**SUBJECT: OCONEE NUCLEAR STATION, UNITS 1, 2, AND 3 – ISSUANCE OF
AMENDMENT NOS. 413, 415, AND 414 REGARDING THE UPDATED FINAL
SAFETY ANALYSIS REPORT SECTION FOR FISSION GAS GAP RELEASE
RATES (EPID NO. L-2018-LLA-0300)**

SAFETY EVALUATION BY THE OFFICE OF NUCLEAR REACTOR REGULATION FOR
AMENDMENT NO. 413 TO RENEWED FACILITY OPERATING LICENSE NO. DPR-38
AMENDMENT NO. 415 TO RENEWED FACILITY OPERATING LICENSE NO. DPR-47
AMENDMENT NO. 414 TO RENEWED FACILITY OPERATING LICENSE NO. DPR-55

OCONEE NUCLEAR STATION, UNITS 1, 2, AND 3

Figure 2-1: Generic PWR AXPDs

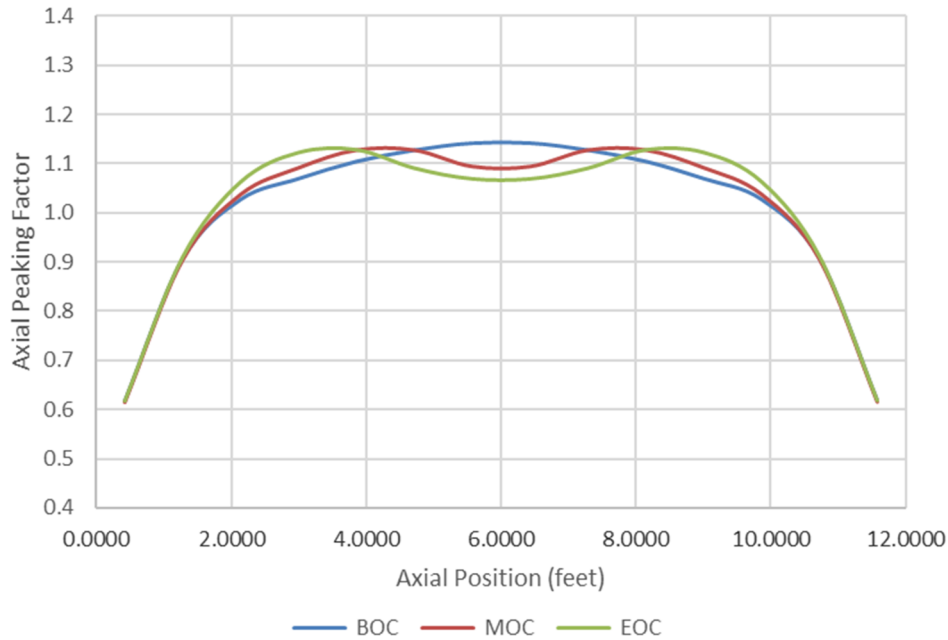
The burnup-dependent AXPD selected for this confirmatory calculation is shown in the below Figure 2-1. These shapes are similar to those used to revise RG 1.183, Table 3, "Non-LOCA Fraction of Fission Product Inventory in Gap" (see Figure A-1 of PNNL-18212, Revision 1). With maximum axial peaking factors (F_z) ranging from 1.143 (beginning-of-cycle (BOC)) to 1.128 (end-of-cycle (EOC)), these axial power distributions are conservatively flat. The combination of these burnup-dependent AXPDs, in combination with the Oconee bounding radial power profile, achieved a peak pellet exposure of 69.3 GWD/MTU at the end-of-life (EOL) burnup target of 62 GWD/MTU.
